# MEMORANDUM

**DATE:** NOVEMBER 28, 2019 **PROJECT:** 116132

**RE:** CLARIDGE / UNIFORM DEVELOPMENT (CU DEVELOPMENTS)  
SANITARY AND WATERMAIN SERVICING OPTIONS

### PROPOSED ALTERNATIVE SANITARY SERVICING FOR FUTURE / EXISTING LANDS

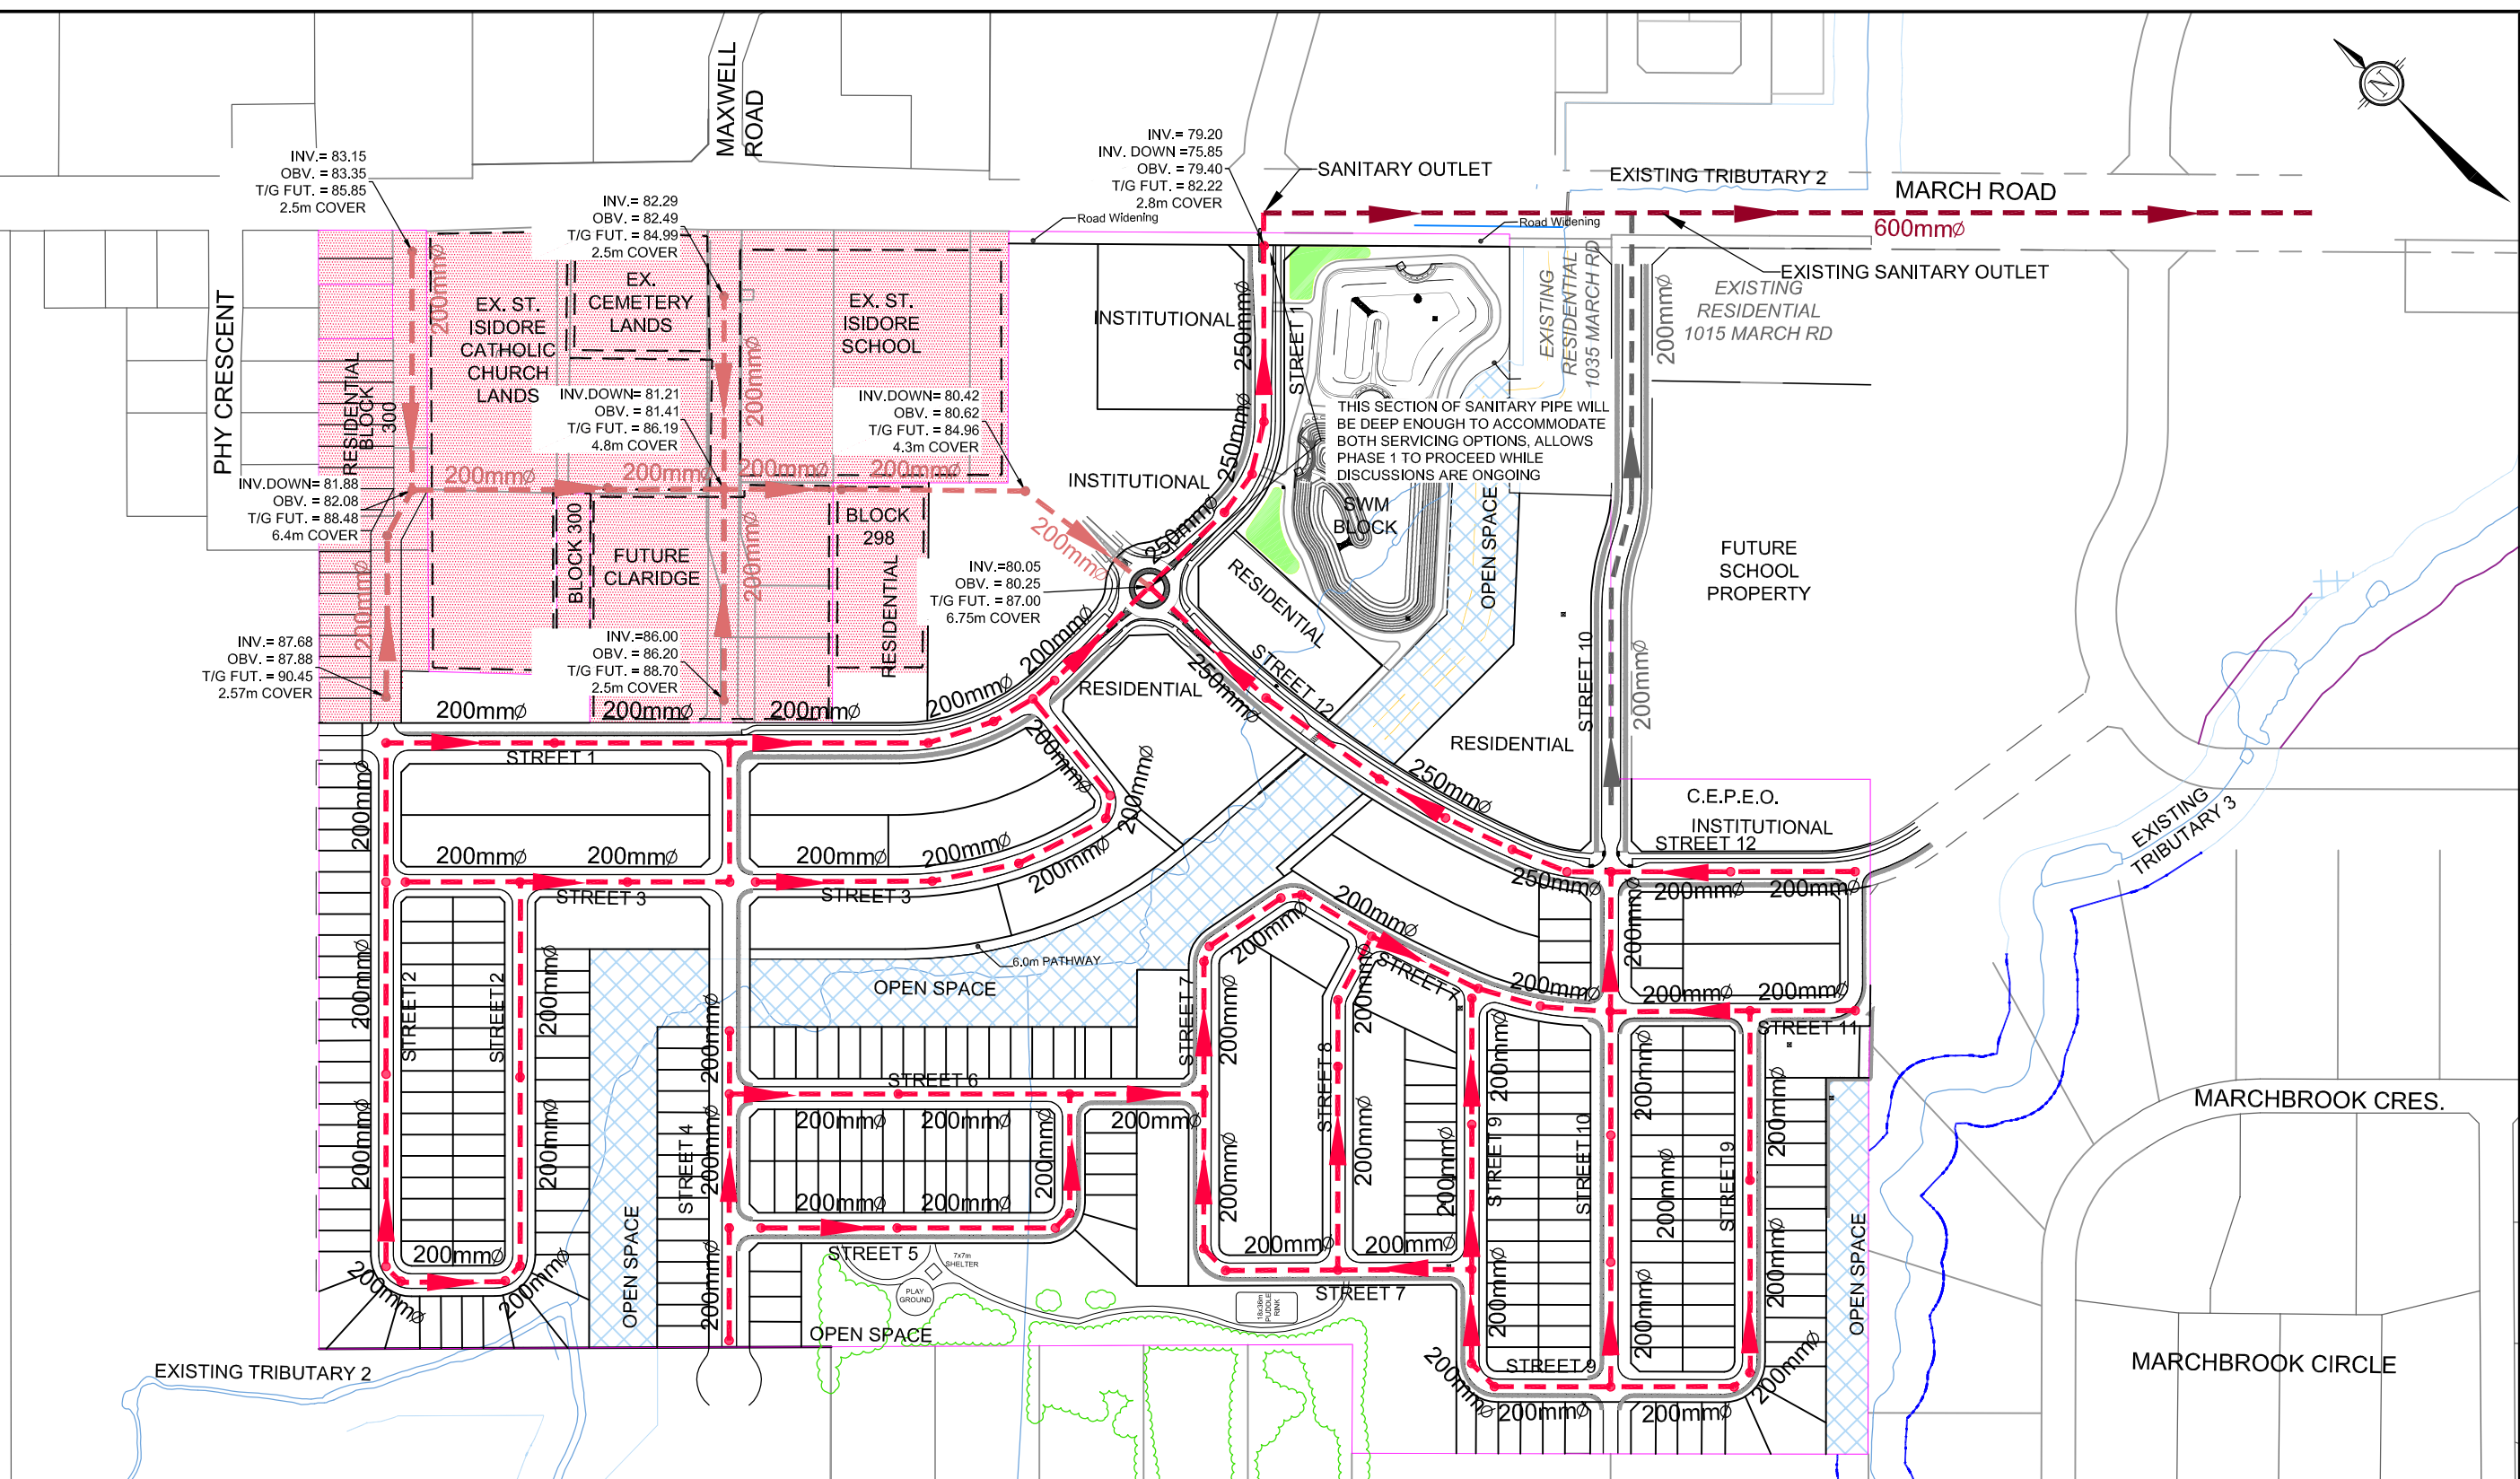
The existing topography slopes west to east with a drop in elevation of approximately 5.0m from Street 1, through the existing / future lands, to March Road. Directing the sanitary flows in a westerly direction results in a sanitary sewer depth of 7.0-8.5m at Street 1. This sanitary approach also forces the sanitary sewer on Street 1 to be at depths of 6.0-8.5m to the March Road connection.

Albeit, the design and construction of the sanitary sewer is achievable, there are factors to consider with the installation and maintenance of sewers depths in excess of 6.0m.

- 1) As identified in the Paterson's geotechnical reports, bedrock ranges from 0.5m to 2.0m below existing ground. Extensive rock blasting will be required;
- 2) Groundwater depth is 1.0m to 2.0m below existing ground. As identified in Paterson's Hydrogeological Investigation report, moderate to high groundwater infiltration through excavated bedrock is expected during construction of the Stormwater Management (SWM) pond. Considering that the sanitary sewer along Street 1 will be of similar pond depths, groundwater management during construction or long-term maintenance will be challenging;
- 3) Long-term maintenance / replacement of sewers with depths 7.0-8.5m within a standard road cross section will result in higher costs for the City of Ottawa.

Refer to Figure 8B – Proposed Alternative Sanitary Servicing for Future / Existing Lands for details.

**PREFERRED SANITARY SERVICING FOR FUTURE / EXISTING LANDS**

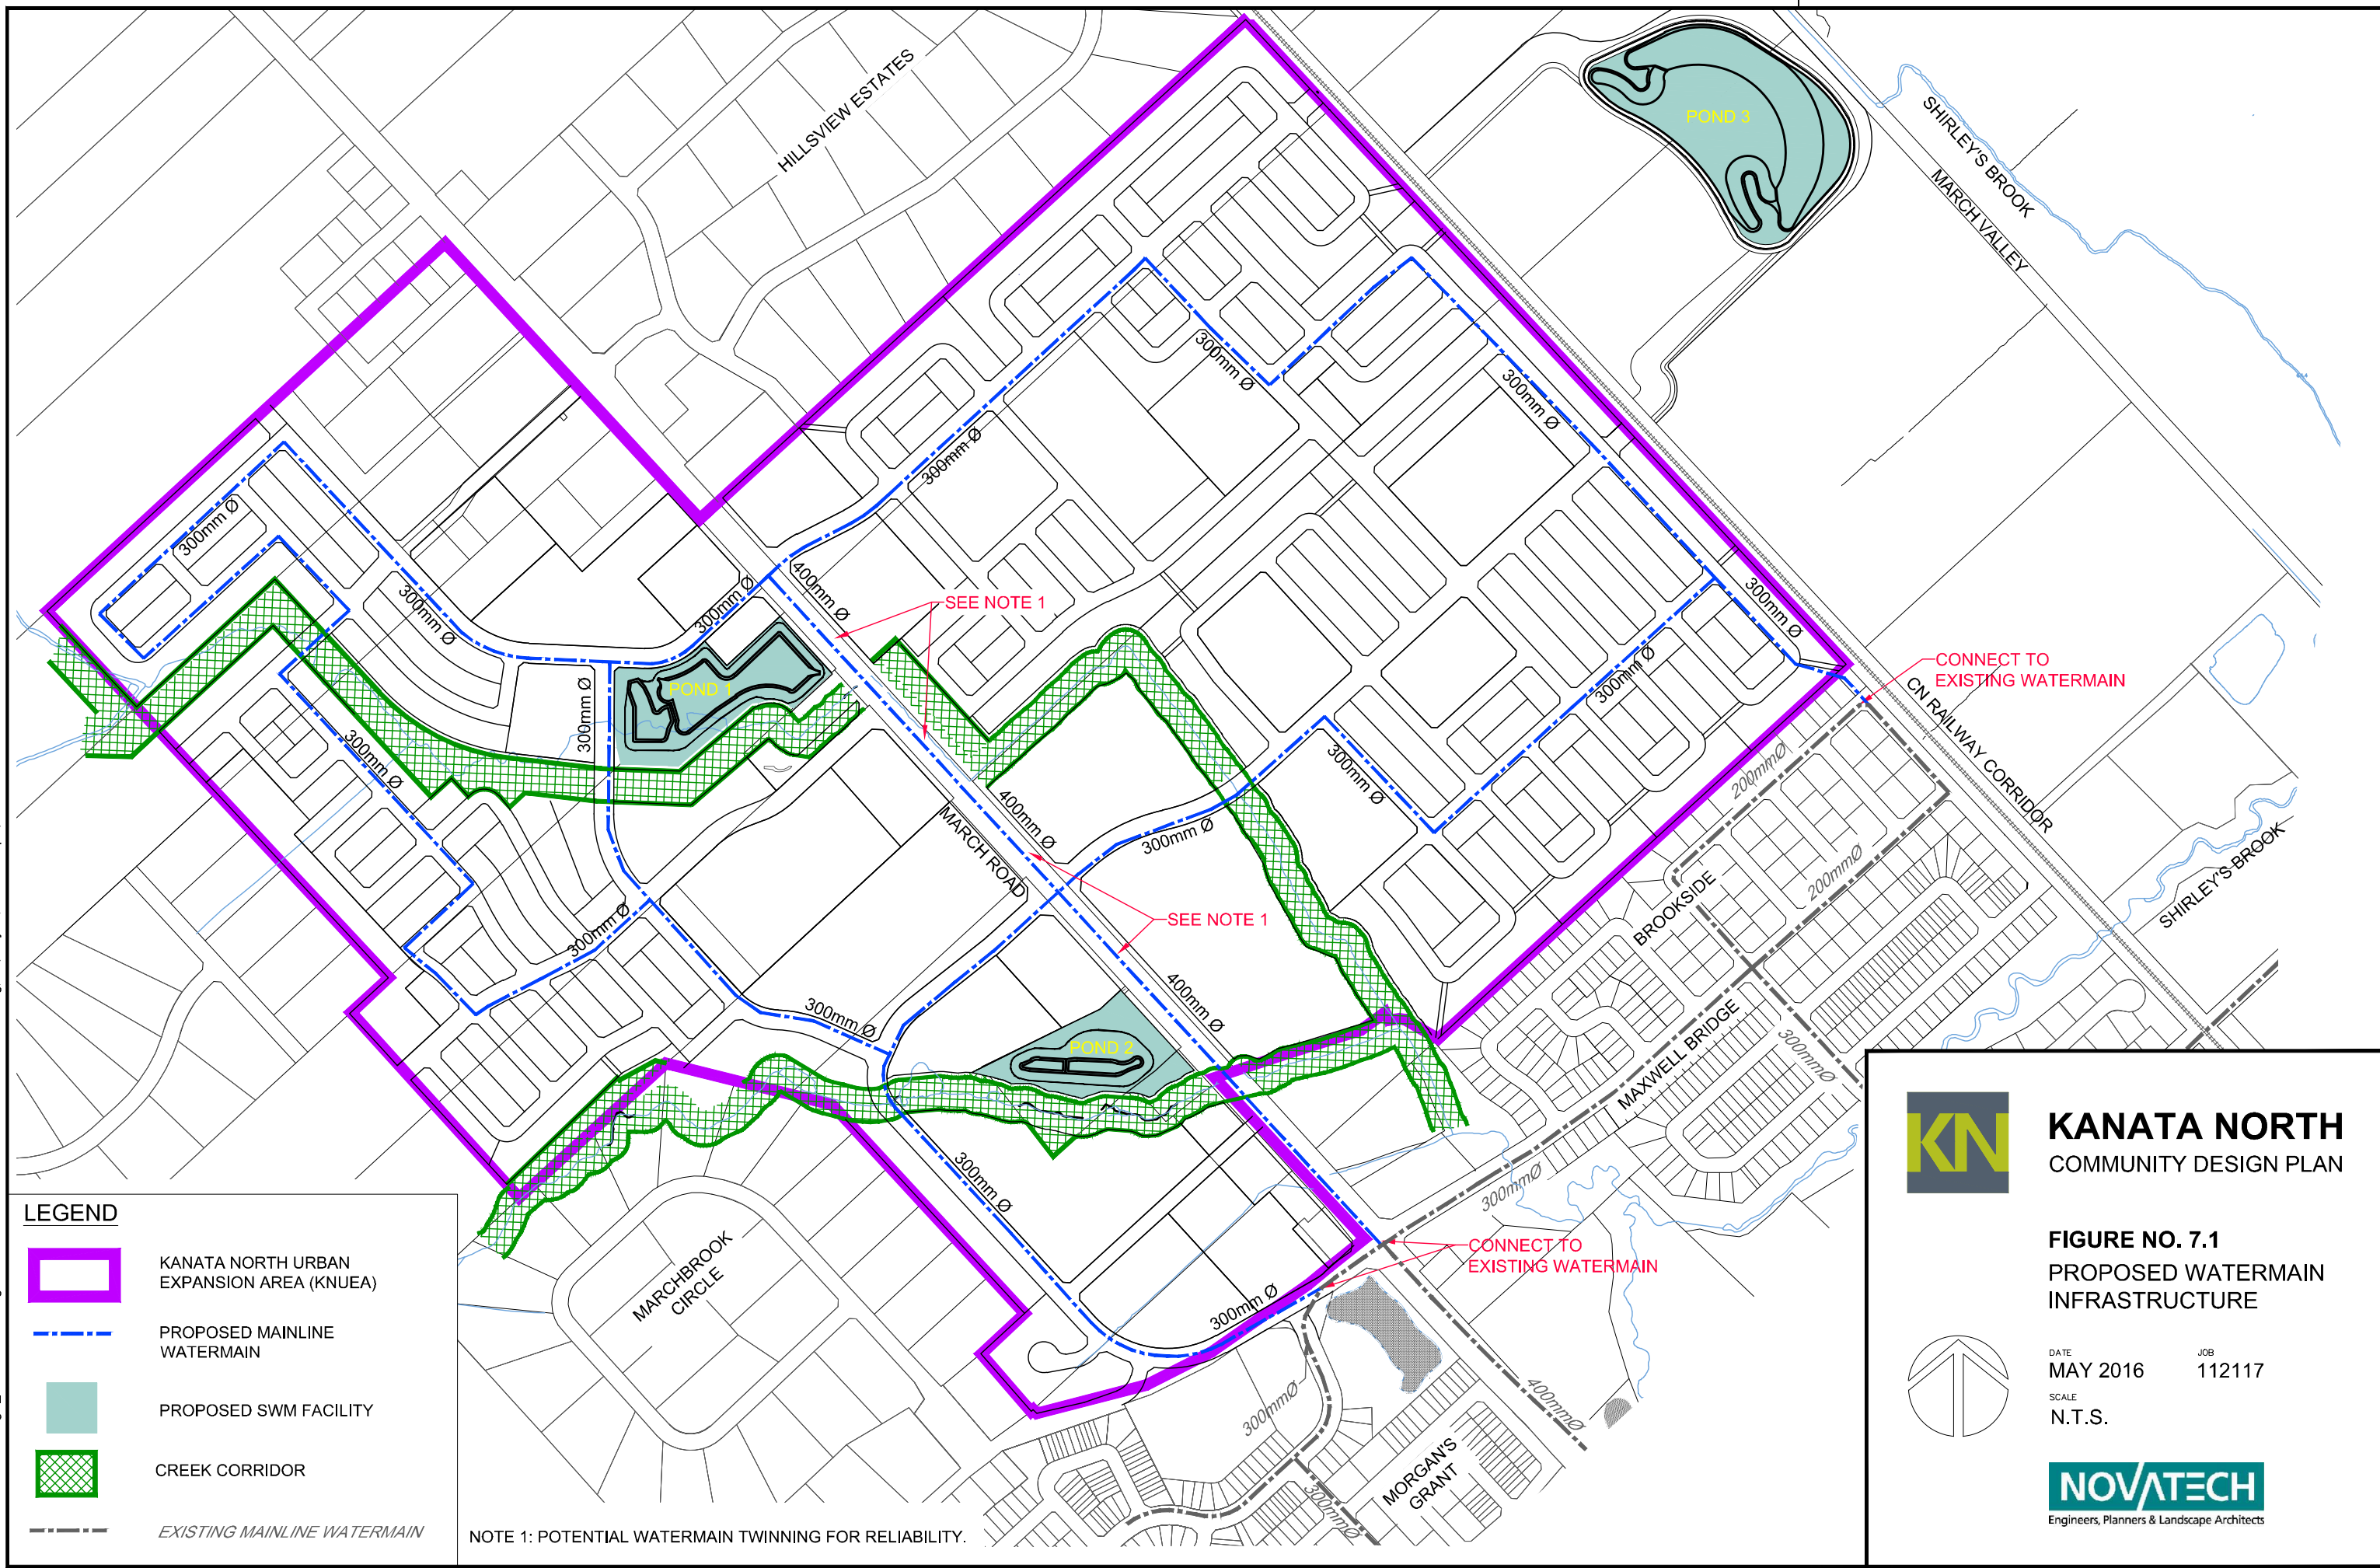
The preferred sanitary servicing location for the existing and future lands is to construct a sanitary sewer through St. Isidore Church lands, cemetery lands, future Claridge lands, Block 298 and the Park & Ride ultimately outletting to Street 1 adjacent to the SWM block. Refer to Figure 8A – Preferred Sanitary Servicing for Future / Existing Lands for details.

- 1) The depth of the sanitary sewer decreases significantly and for the most part, can be designed and constructed at a depth of about 5.0m. Sewer depths will be about 6.0m in a localized location. The sanitary sewer depths along Street 1 will also be decreased with average depths of about 4.5m;
- 2) The depth of trench rock blasting and excavation decreased significantly;
- 3) Groundwater infiltration during construction can be easily managed.

As mentioned, the sanitary sewer would be located through the future Park & Ride. In discussions with the City, it's been informed that the City's transit department will require additional time to review our preferred sewer location. Since the development of the Park & Ride is unknown and subject to lands being acquired by the City, the review of our proposal could be delayed for some period of time.

As an additional measure to the preferred sanitary service option, we propose that the sanitary sewer on Street 1, from the roundabout to the March Road trunk sewer connection, be designed and constructed to an over depth elevation. This would allow 2 things:

- 1) The over depth sewer through this reach allows connections to both the preferred option and the alternative option in the future.
- 2) Phase 1 construction can proceed while discussions continue with the City on the preferred servicing of the existing / future lands.
